TECHNICAL NOTE

PROJECT	:	Land adjacent Sefter School House, Sefter Road, Pagham
NOTE REF.	:	Acl640/21023/TN
NOTE TITLE	:	Additional Information requested by the LLFA
AUTHOR	:	Tafari Lewis
APPROVED	:	Tafari Lewis
DATE	:	11 th March 2022

Trial Pit Falling Head Soakage Test Results - TP02 Test 3

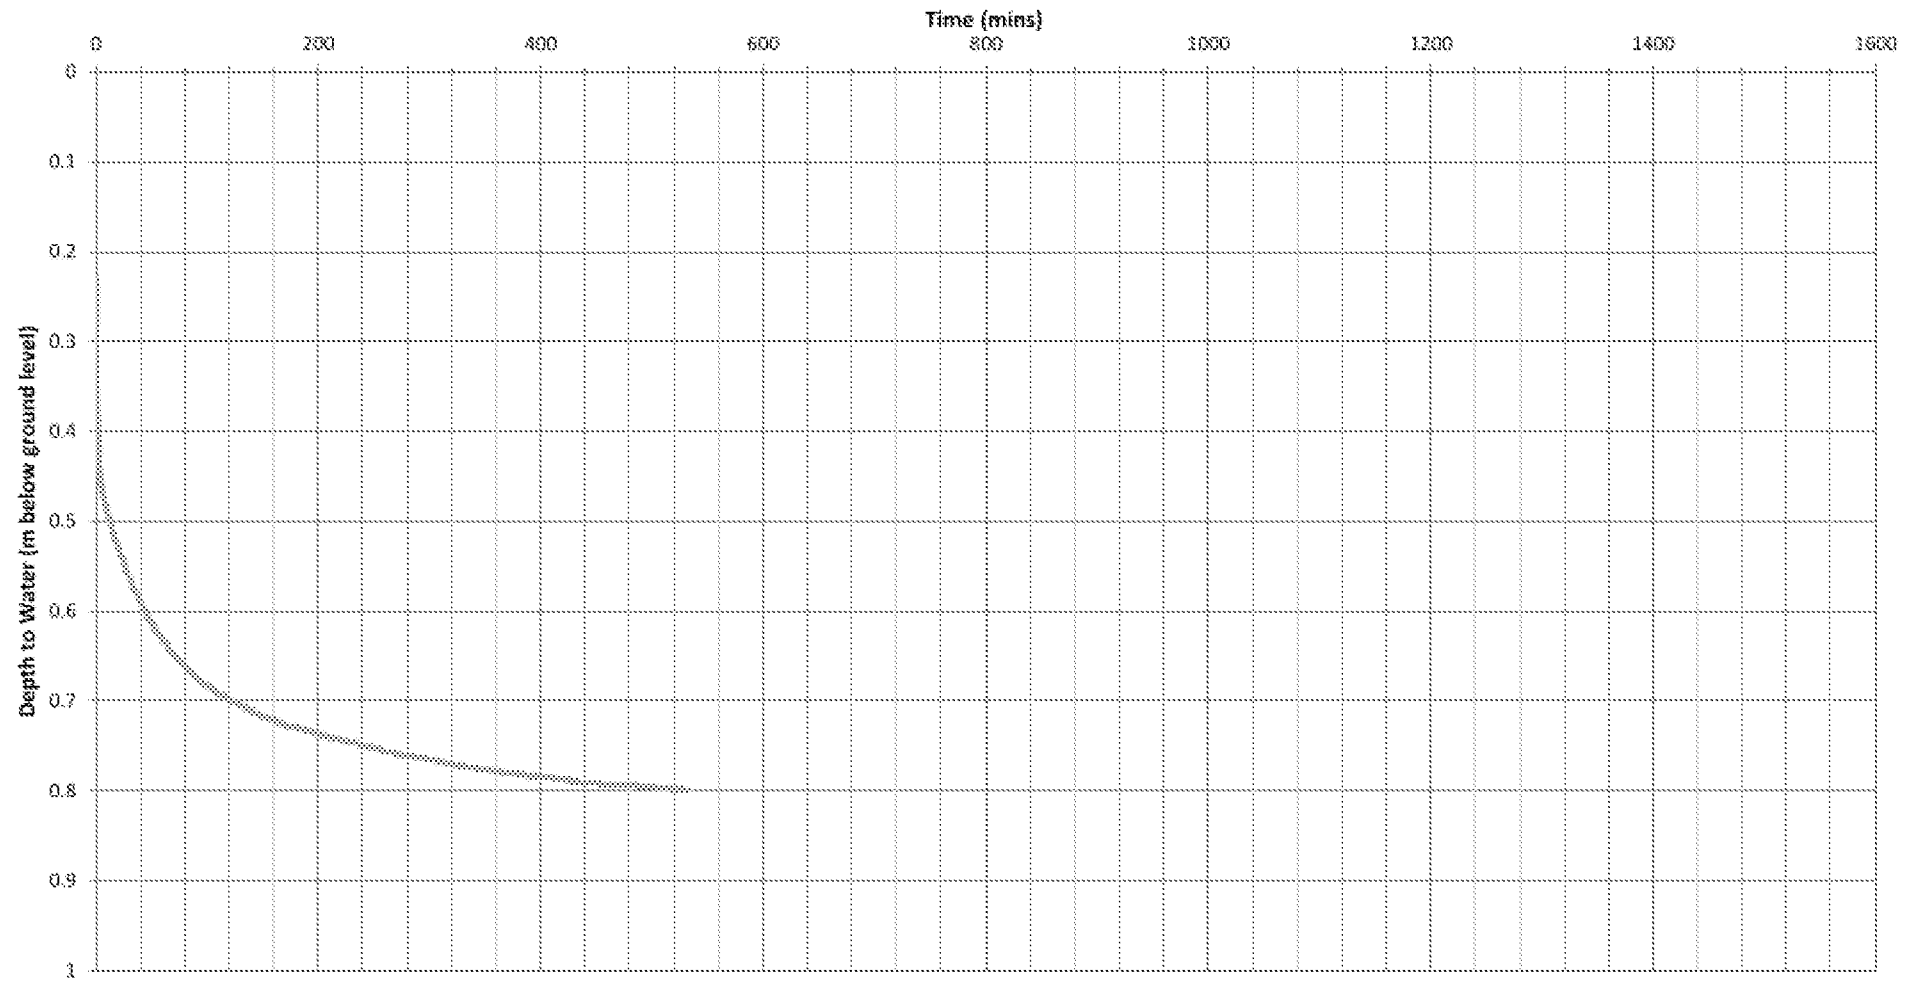
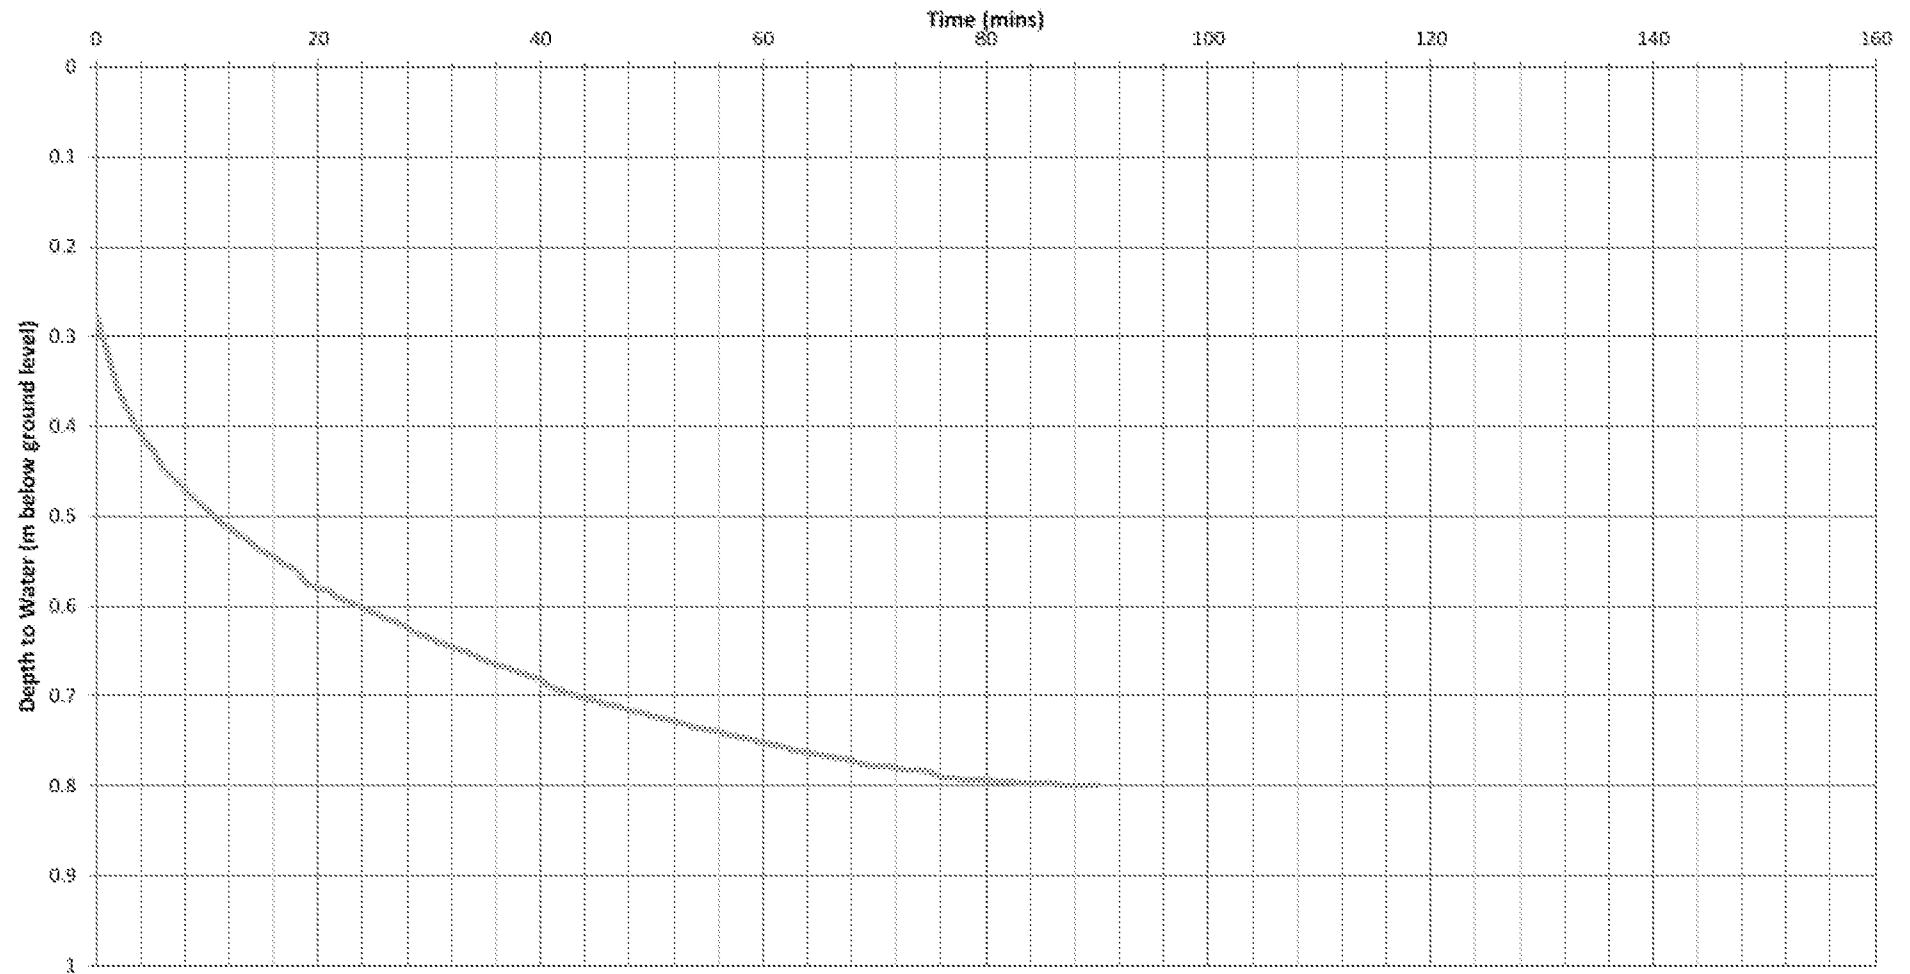
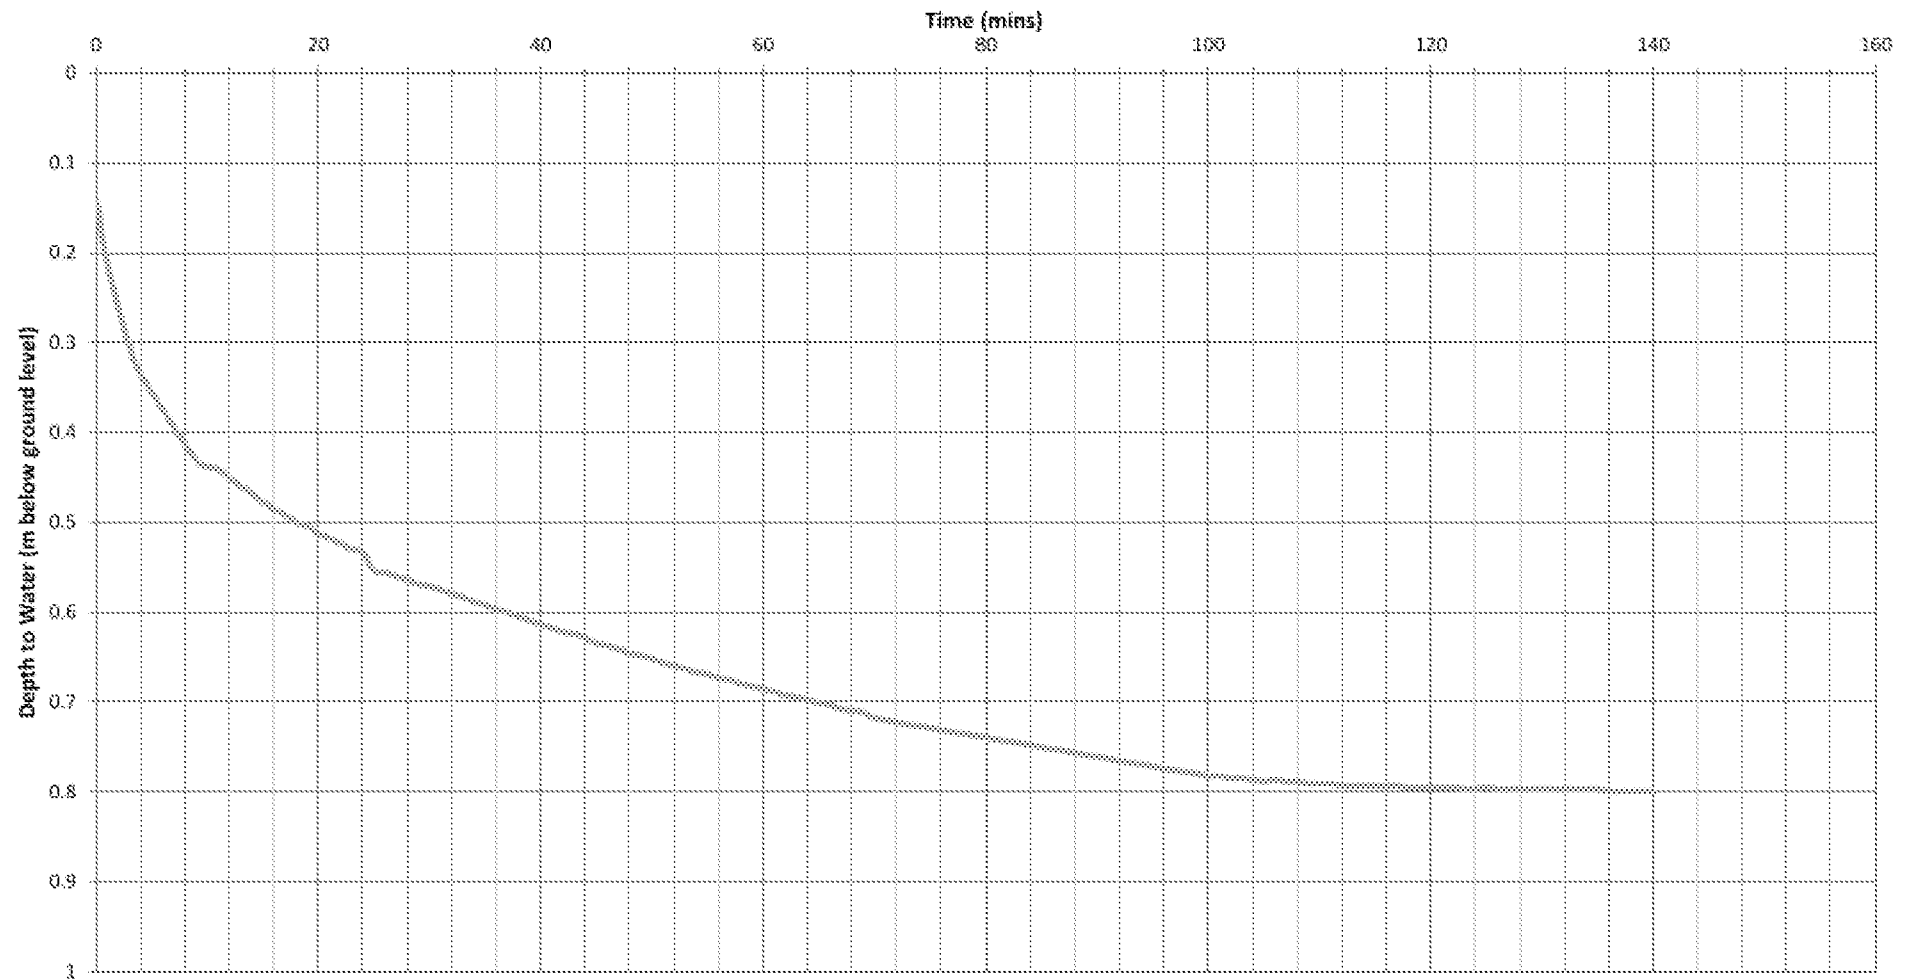
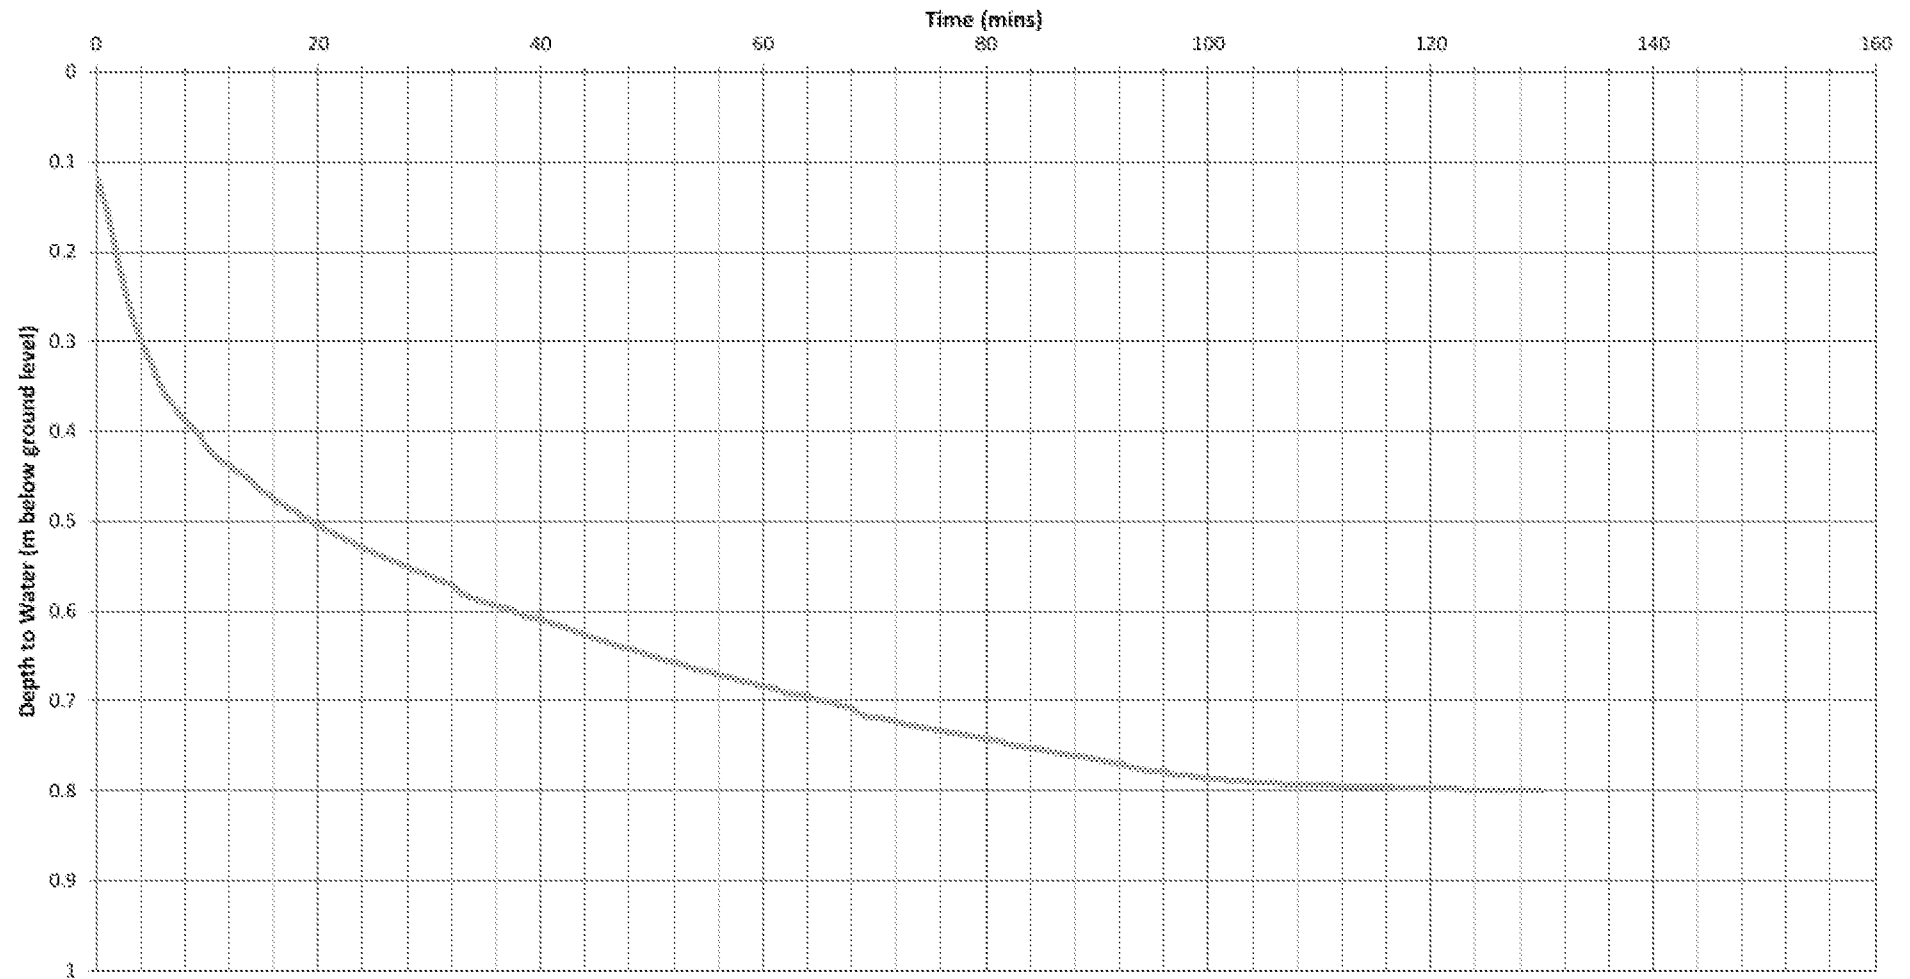
"No winter infiltration testing has been completed. It is considered that infiltration is unlikely to work here, however this should be supported by on site infiltration testing."

Refer to Ashdown Site Investigations Ltd infiltration testing report in **Appendix B**.

Groundwater Monitoring Results - WS01

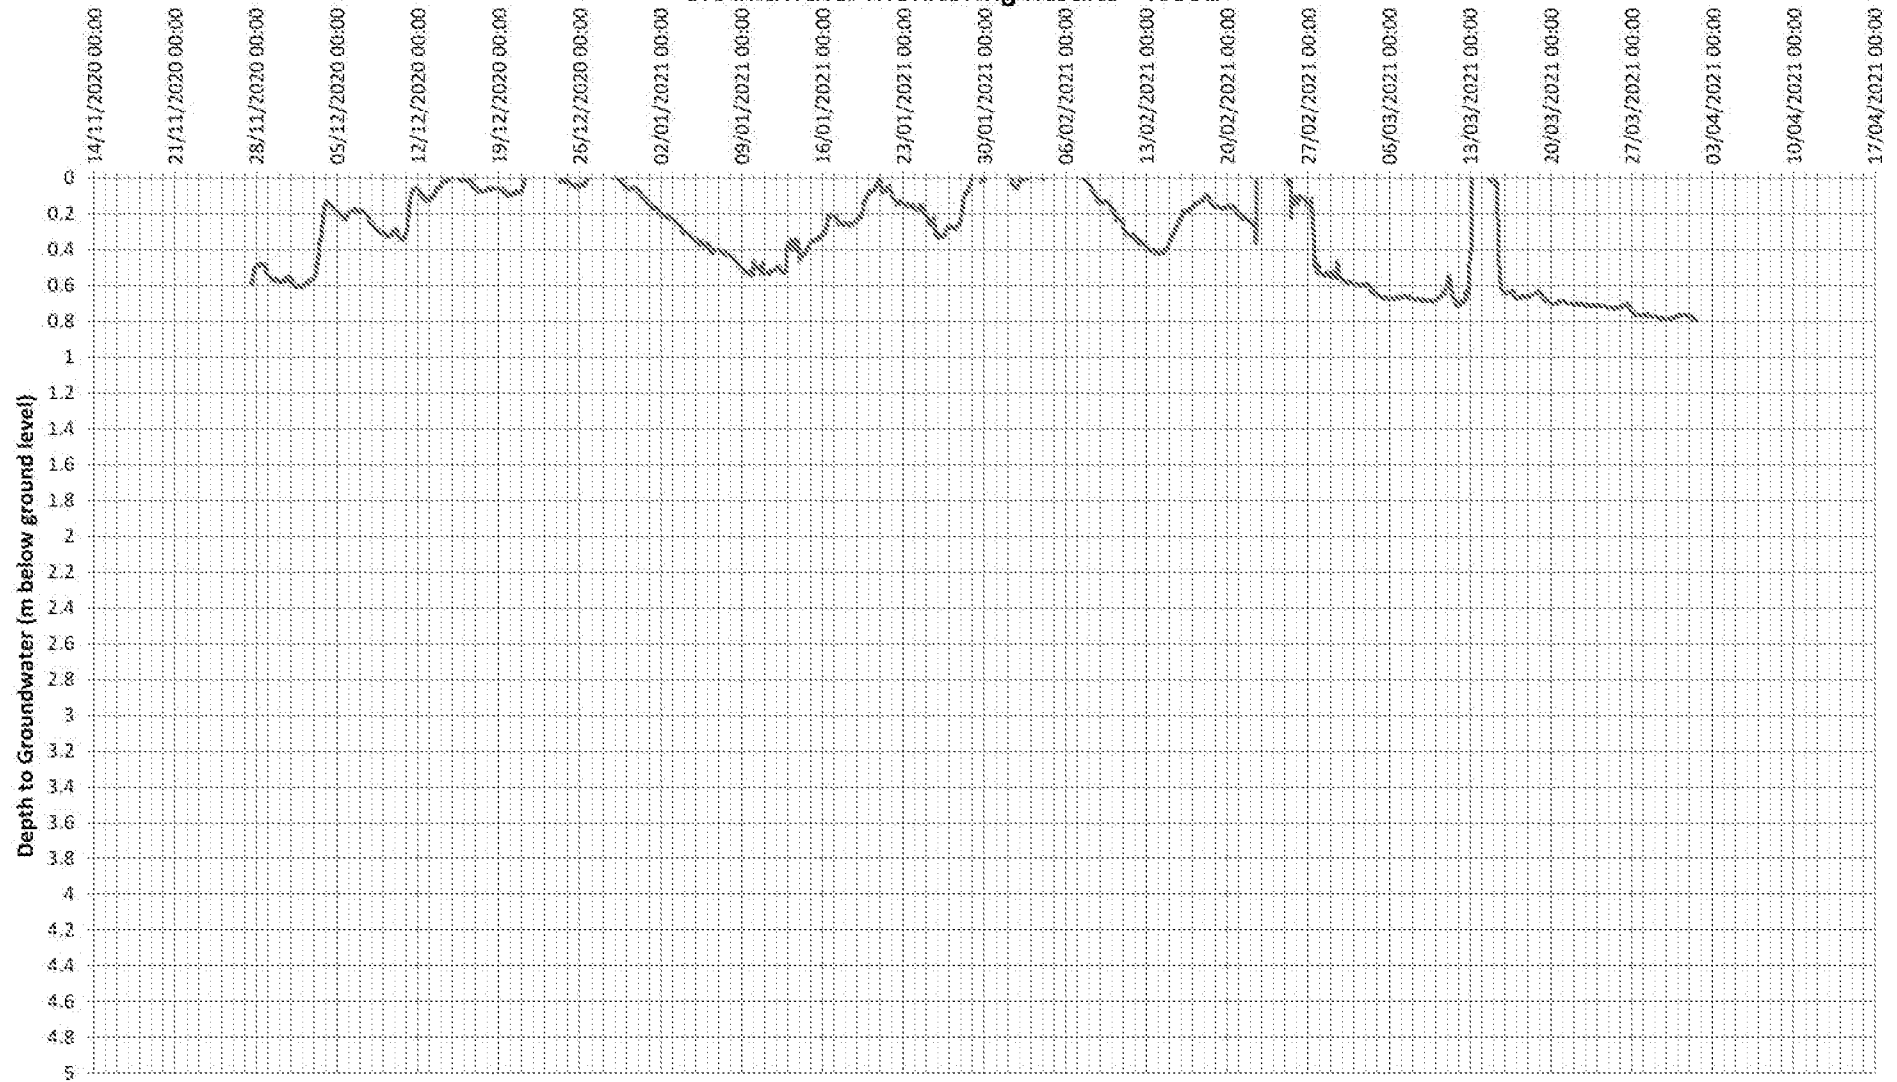
"No winter groundwater monitoring has been completed. Observed perched groundwater at 1m depth in August is noted within the report. This is not winter groundwater monitoring. Even when infiltration is not deemed suitable, we require on site winter groundwater monitoring to establish peak seasonal groundwater levels and ensure that attenuation design appropriately considers and resists flotation. Please complete and supply winter groundwater monitoring ."

Ashdown Site Investigation Limited undertook In Situ Infiltration testing and groundwater monitoring between November 2020 and March 2021.

The conclusions drawn from the monitoring visits which were provided in graph format and showed groundwater fluctuations between 0.8m below ground level (bgl) to near surface level.

A copy of Ashdown Site Investigation reports inclusive winter groundwater monitoring is annexed within **Appendix B**.

Technical Specification

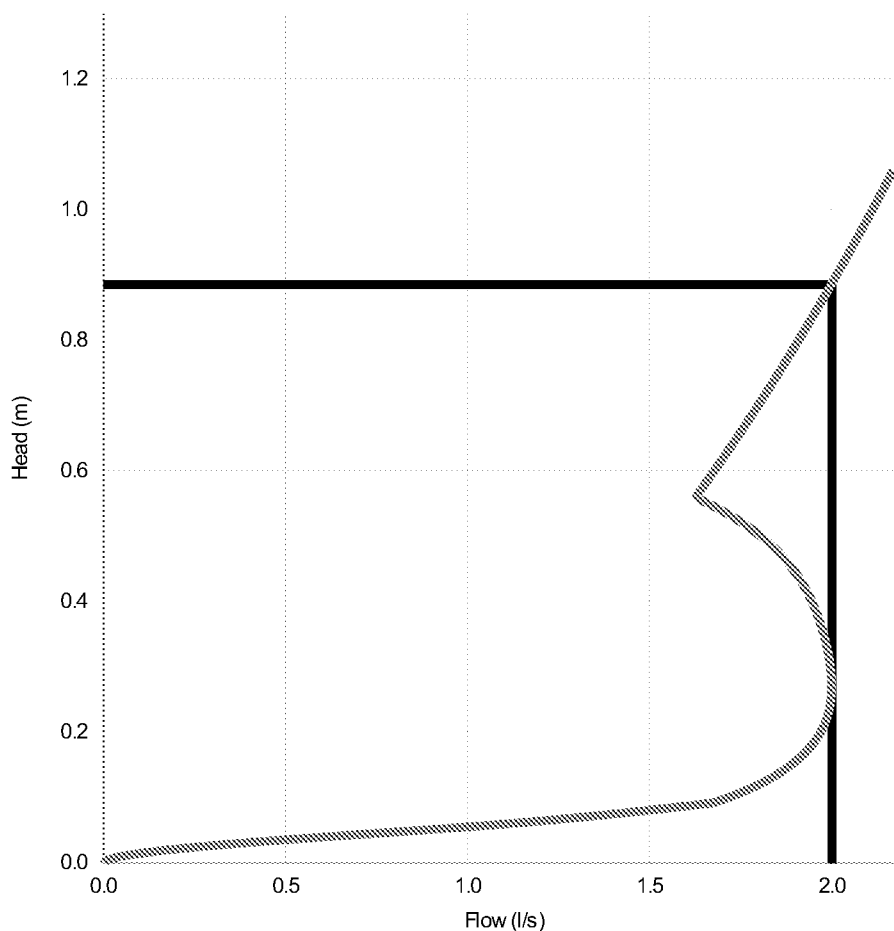
"Hydrobrake unit reference must be stated on plan".

Topographic Survey

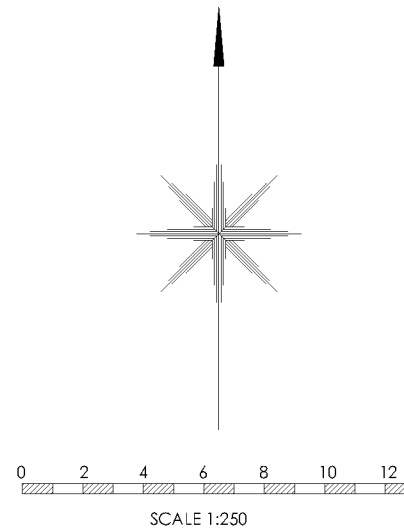
"We note that the levels of the ditch are shown to drop away sharply nearly the point of proposed connection. Please check all ditch levels on site. Please also provide downstream culvert invert levels, as well as soft and hard bed levels of the watercourse. An extended outfall pipe is proposed to get the discharge to the area where the watercourse is deeper. However, it may be that soft bed levels are shown upstream and that a discharge point closer to the hydrobrake, and drainage features is actually achievable with necessary maintenance completed to the watercourse."

At the time of this response additional topographic data was unavailable to check ditch levels on site together with the downstream culvert. The drainage scheme has therefore been based on the Medlams Surveys limited Topographic survey conducted in December 2019 (reproduced within **Appendix E**).
